400 MAIN STREET, MAIL STOP 121-10
EAST HARTFORD, CT 06108, USA.
TELEPHONE:- 860 565 5515

V2500-A1/A5 SERIES PROPULSION SYSTEM SERVICE BULLETIN

This document transmits the Revision 1 of Service Bulletin V2500-ENG-75-0094.

AIR – ACTIVE CLEARANCE CONTROL (ACC) – TO INCORPORATE THE OVERSIZE BUSHES OF THE ACC
HOUSING ASSEMBLY

ACC Housing Assembly – Before and After Alteration
Figure 1

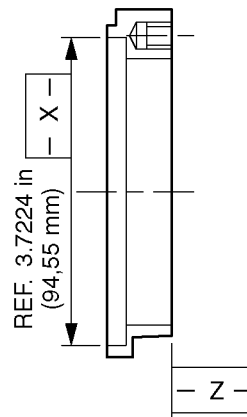
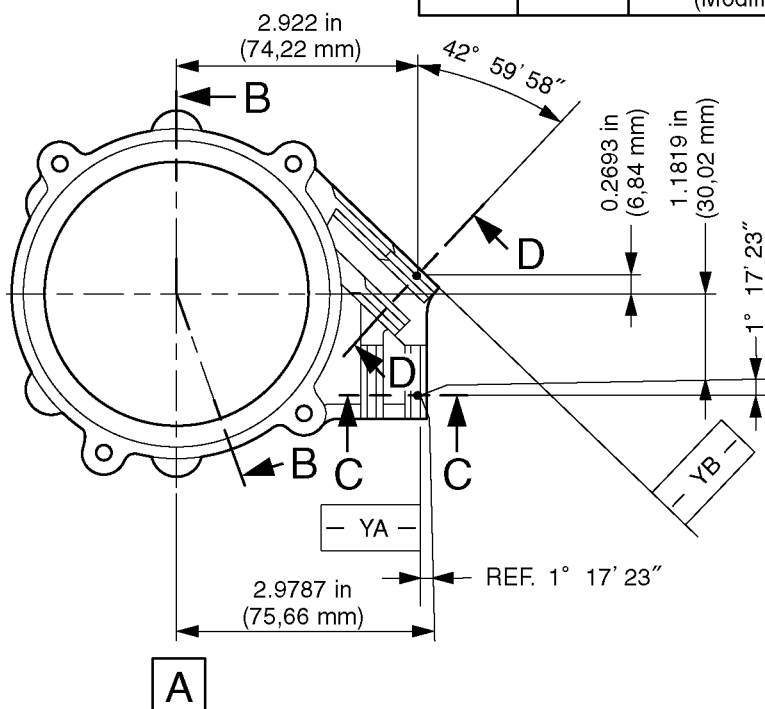
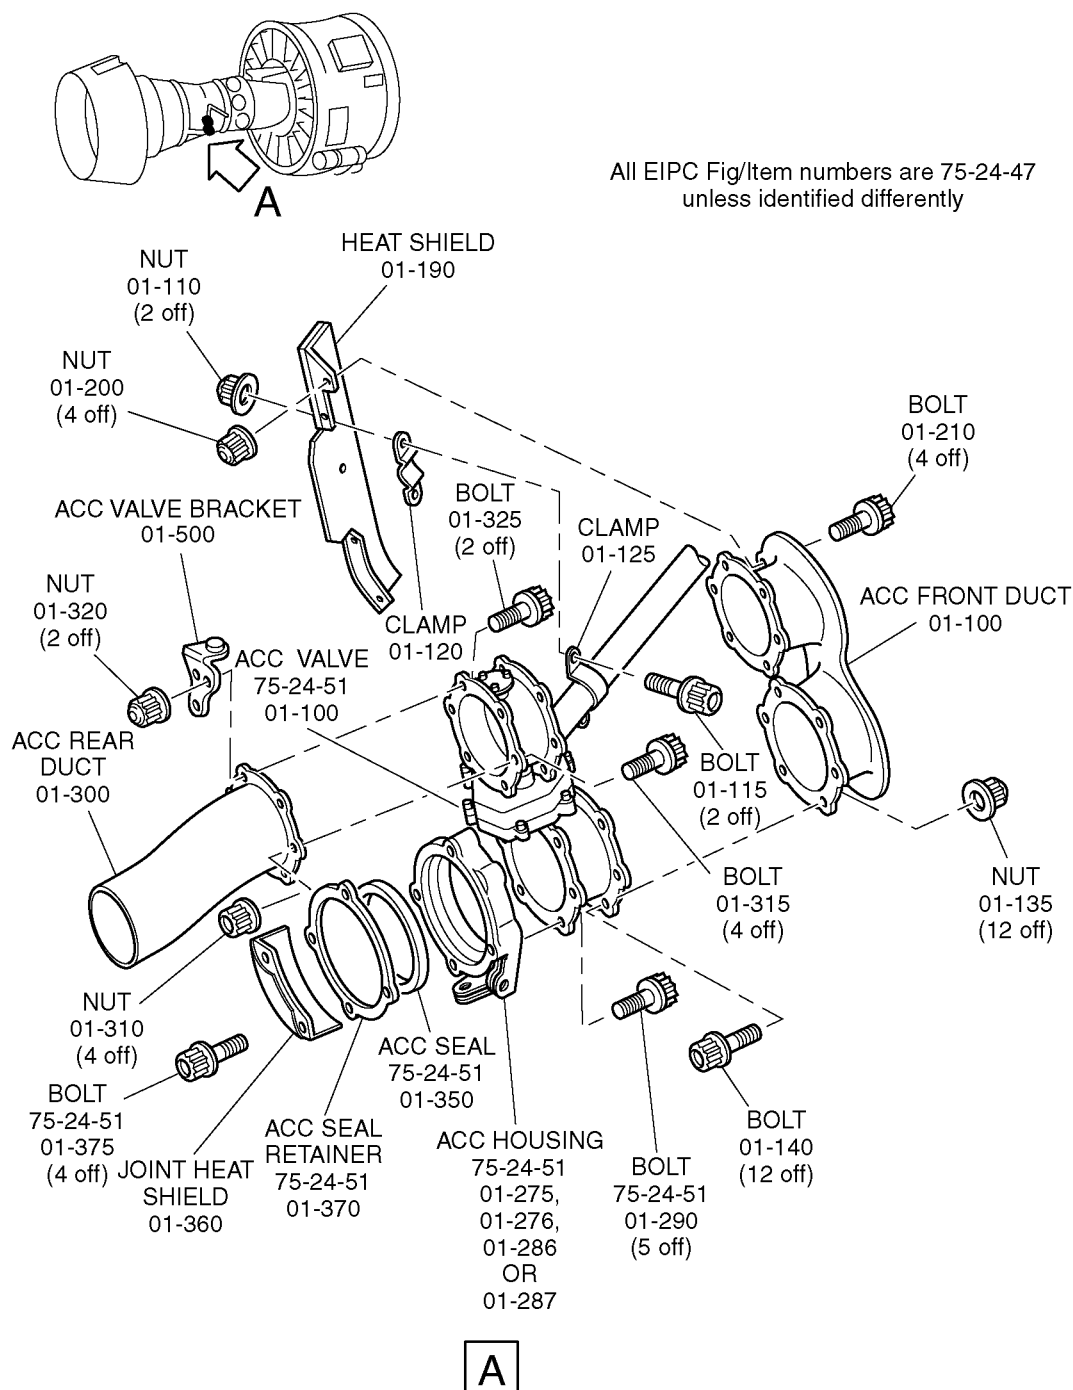
- (1) The oversize bush is introduced by this service bulletin. The oversize bush is used after ACC housing assembly is reworked.

- (2) Existing 2A1512, ACC housing assembly can be reworked to the following new part numbers.

- (3) Existing 2A1534, ACC housing assembly can be reworked to the following new part numbers.

| <p>(a) Drill the holes position A1 and A2 of ACC housing assembly, if inner diameter is more than 0.363in (9,219 mm) at hole position A1 or A2.</p> | <p>Refer to Figure 1.</p> |
| <p>(b) Drill the holes position B1 and B2 of ACC housing assembly, if inner diameter is more than 0.363in (9,219 mm) at hole position B1 or B2.</p> | <p>Refer to Figure 1.</p> |

ENLARGE FROM $\phi 0.3625 \sim 0.3629$ in
($\phi 9,207 \sim 9,219$ mm)
TO $\phi 0.3861 \sim 0.3865$ in
($\phi 9,807 \sim 9,819$ mm)

ENLARGE FROM $\phi 0.3571 \sim 0.3629$ in
($\phi 9,07 \sim 9,219$ mm)
TO $\phi 0.3861 \sim 0.3865$ in
($\phi 9,807 \sim 9,819$ mm)

ACC HOUSING ASSEMBLY PART NUMBER		HOLE POSITION & SIZE	
		A1 & A2	B1 & B2
2A1512	2A1534	$\phi 0.3625 \sim 0.3629$ in ($\phi 9,207 \sim 9,219$ mm) (Original)	$\phi 0.3625 \sim 0.3629$ in ($\phi 9,207 \sim 9,219$ mm) (Original)
2A3735	2A1587	$\phi 0.3861 \sim 0.3865$ in ($\phi 9,807 \sim 9,819$ mm) (Modified)	$\phi 0.3625 \sim 0.3629$ in ($\phi 9,207 \sim 9,219$ mm) (Original)
2A3736	2A1588	$\phi 0.3625 \sim 0.3629$ in ($\phi 9,207 \sim 9,219$ mm) (Original)	$\phi 0.3861 \sim 0.3865$ in ($\phi 9,807 \sim 9,819$ mm) (Modified)
2A3737	2A1589	$\phi 0.3861 \sim 0.3865$ in ($\phi 9,807 \sim 9,819$ mm) (Modified)	$\phi 0.3861 \sim 0.3865$ in ($\phi 9,807 \sim 9,819$ mm) (Modified)

Record Sheet -
ACC Housing Assembly Part Number
and Bush Part Number

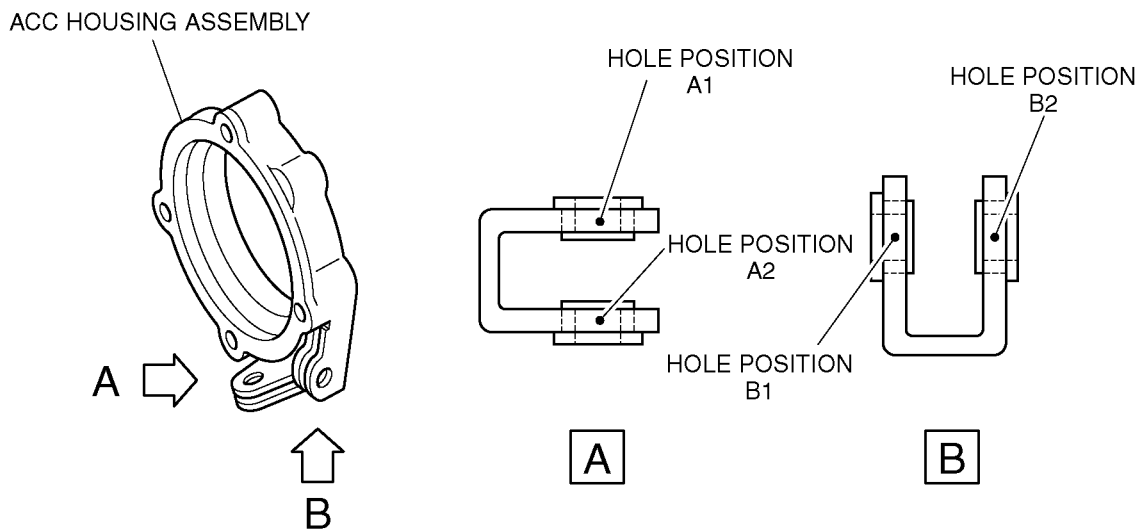
- (4) The installation procedure of the ACC housing assembly and the bush is changed. Please note the combination of the bush and the ACC housing assembly. Refer to Figure 2.

- (m) Identify the bush part numbers.
 - (i) Find the part number of the ACC housing assembly. Use record sheet.
 - (ii) Identify the part number of the bush in accordance with the record sheet.

ACC HOUSING ASSEMBLY PART NUMBER	BUSH PART NUMBER	
	HOLE POSITION A1 & A2	HOLE POSITION B1 & B2
□2A1534 OR 2A1512	5W2059	5W2059
□2A1587 OR 2A3735	6A8297	5W2059
□2A1588 OR 2A3736	5W2059	6A8297
□2A1589 OR 2A3737	6A8297	6A8297

Family Tree – ACC Housing Assembly
Figure 3

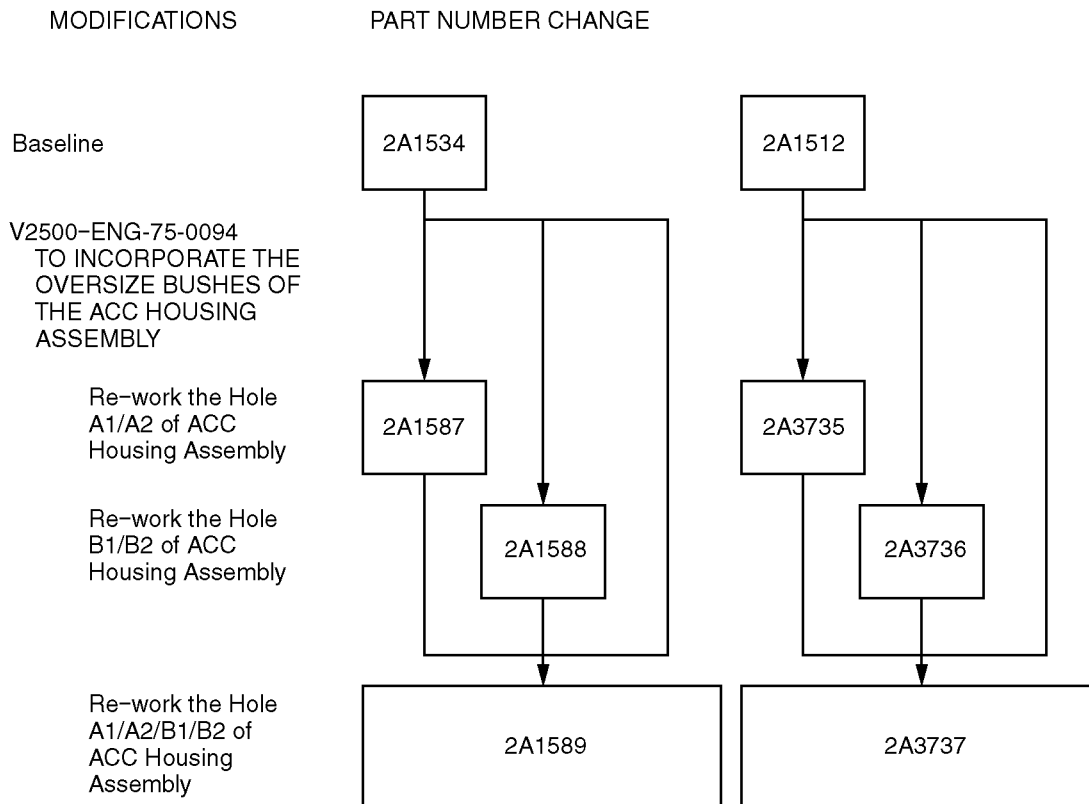
- (g) Identify the part number of modified ACC housing assembly in accordance with the figure 1 and figure 3. Re-identify the part adjacent to existing part number by electrochemical marking. Cross off the existing part number with a double line.
- Refer to Figure 1 and Figure 3.

New P/N	Existing P/N
2A3735, 2A3736 or 2A3737	2A1512
2A1587, 2A1588 or 2A1589	2A1534
2A1589	2A1587
2A1589	2A1588
2A3737	2A3735
2A3737	2A3736
